**STAFF RECOMMENDATION**  
**1821 5<sup>th</sup> Avenue North**  
**July 20, 2016**

**Application:** New construction—detached accessory dwelling unit;  
**District:** Salemtown Neighborhood Conservation Zoning Overlay  
**Council District:** 19  
**Map and Parcel Number:** 08108026200  
**Applicant:** Cheyenne Smith  
**Project Lead:** Melissa Baldock, melissa.baldock@nashville.gov

<p><b>Description of Project:</b> Application is to construct a detached accessory dwelling unit (DADU) at the rear of the lot.</p> <p><b>Recommendation Summary:</b> Staff recommends approval of the detached accessory dwelling unit with the following conditions:</p> <ol style="list-style-type: none"><li>1. Staff review and approve all windows and doors; and</li><li>2. Staff review and approve the asphalt shingle color.</li></ol> <p>With these conditions, staff finds that the detached accessory dwelling unit meets Ordinance 17.16.030. G. and Section III.H. of the Salemtown Neighborhood Conservation Zoning Overlay design guidelines.</p> <p>The Commission does not have the authority to approve the use. This recommendation is for the design of the building based on the proposed use.</p>	<p><b>Attachments<

Figure 1. 1821 5<sup>th</sup> Avenue North.

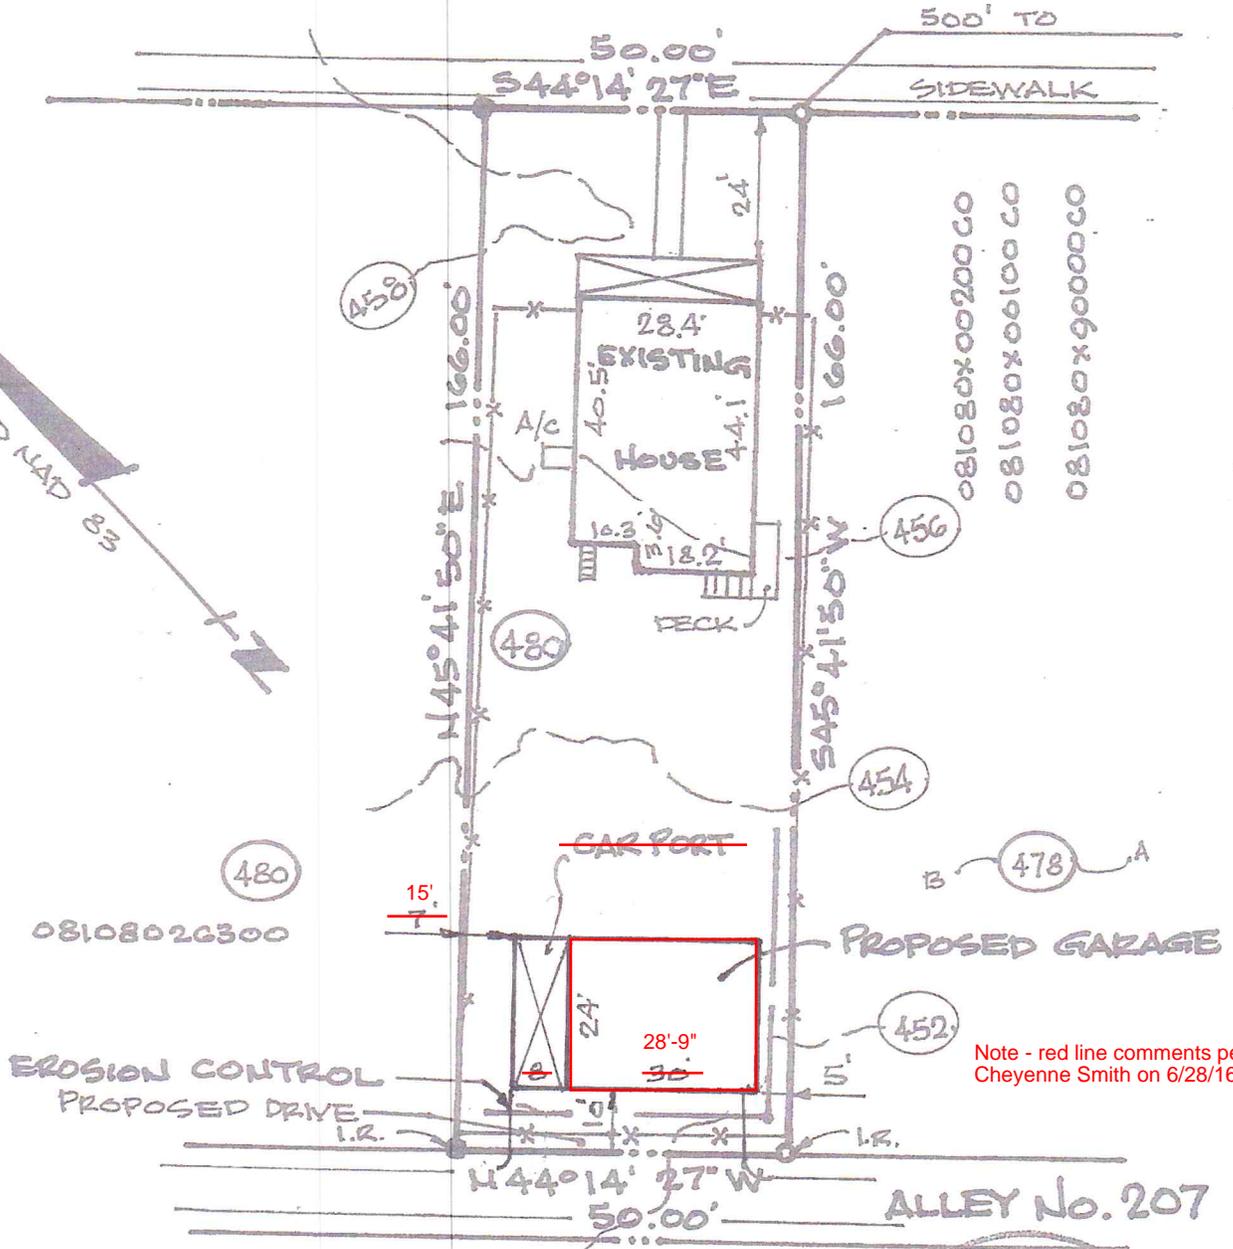
**Background:** 1821 5<sup>th</sup> Avenue North is a c. 1930 bungalow (figure 1). It is a contributing structure to the Salemtown Neighborhood Conservation Zoning Overlay.

**LOT SURVEY and PLOT PLAN**

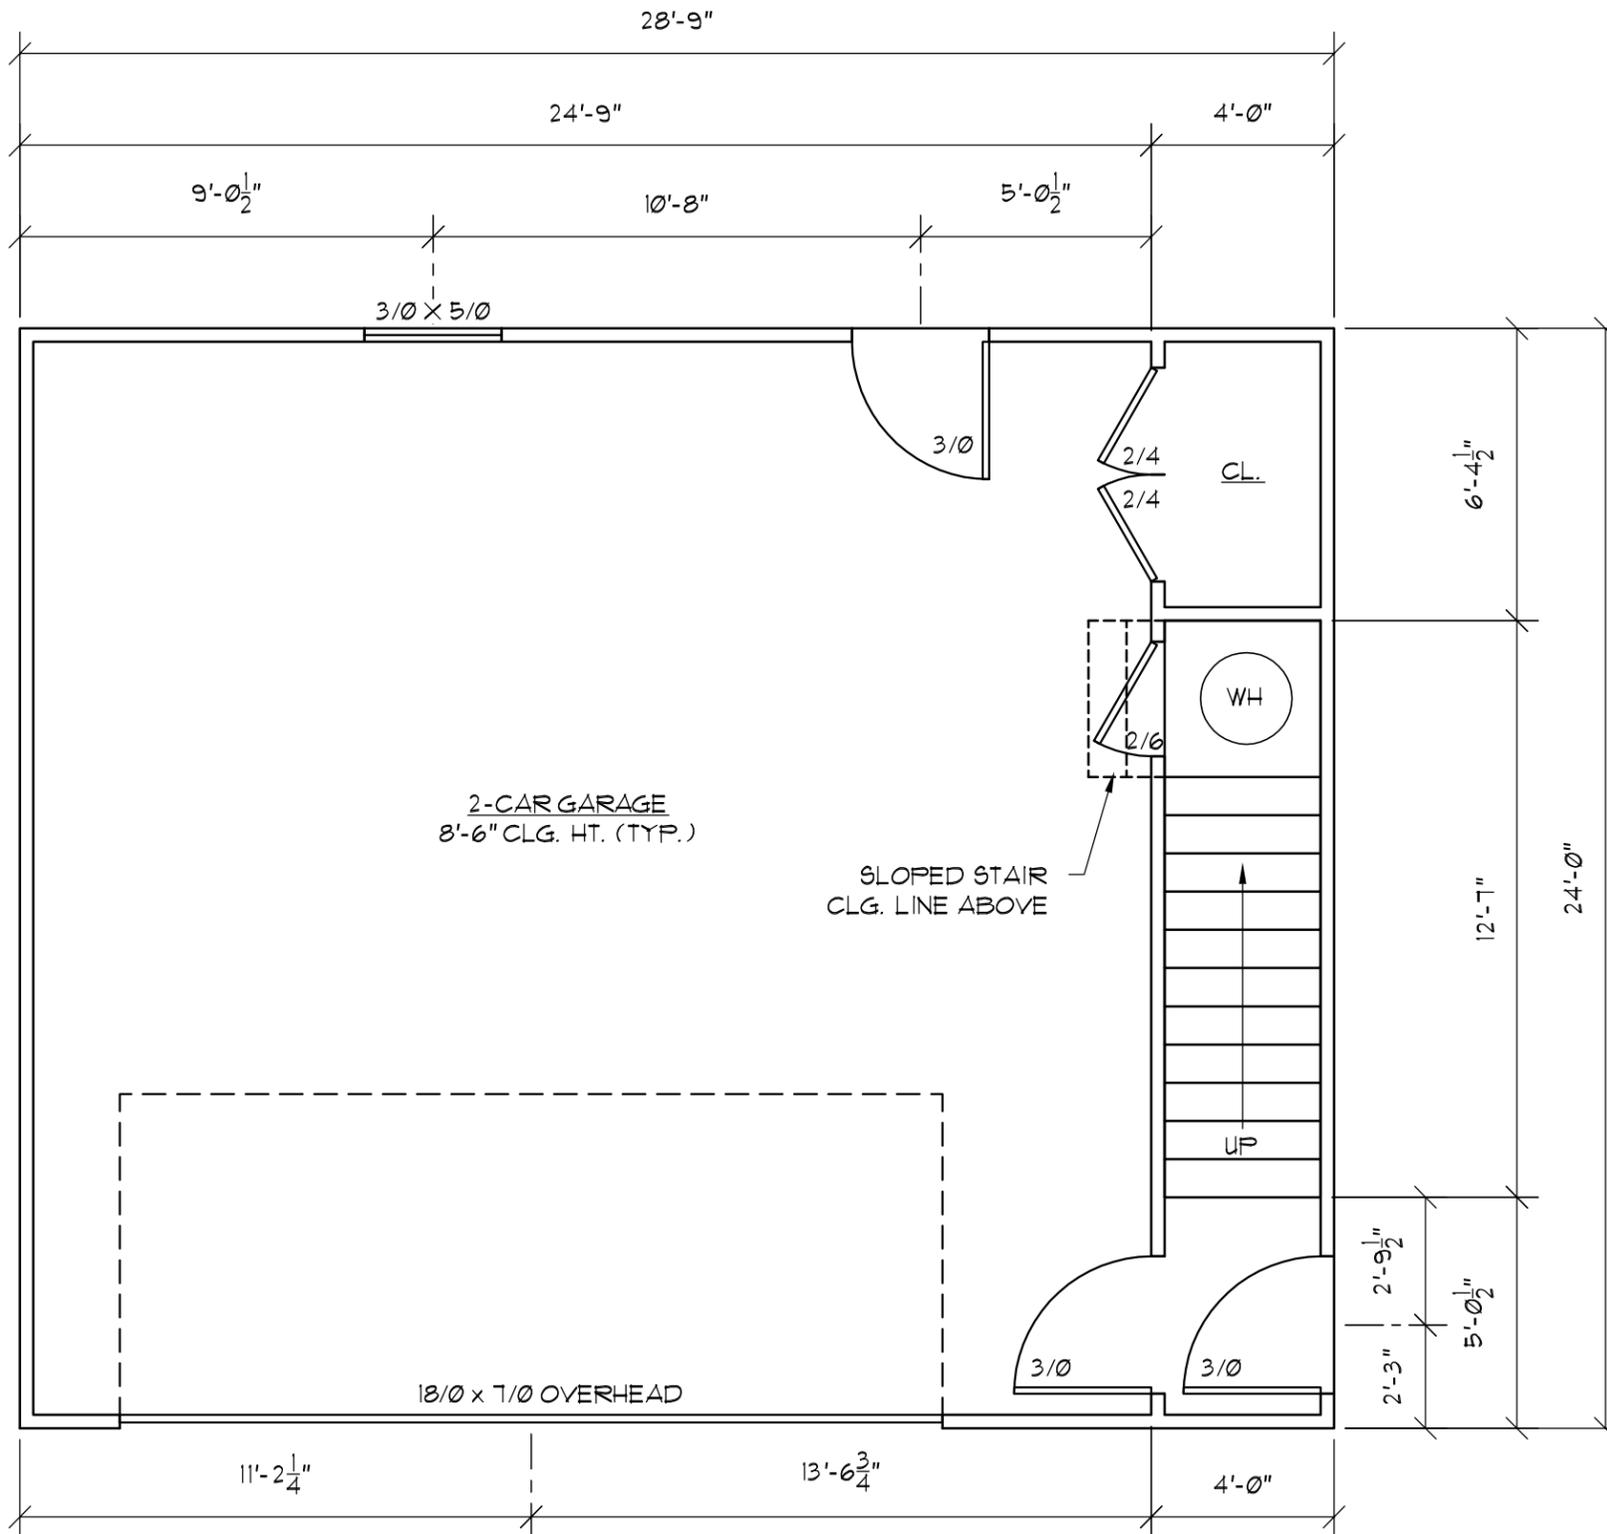
Site Planning & Setbacks: The proposed DADU meets all base zoning setbacks. Staff finds that the DADU meets Sections III.G. and III.H. of the design guidelines and 17.16.30.G. 4 of the ordinance.

MINIMUM	PROPOSED
Space between principal building and DADU/Garage	20'	52'
Rear setback	3'	10'
L side setback**	3'	5'
R side setback**	3'	16'
How is the building accessed?	From the alley or existing curb cut	Alley
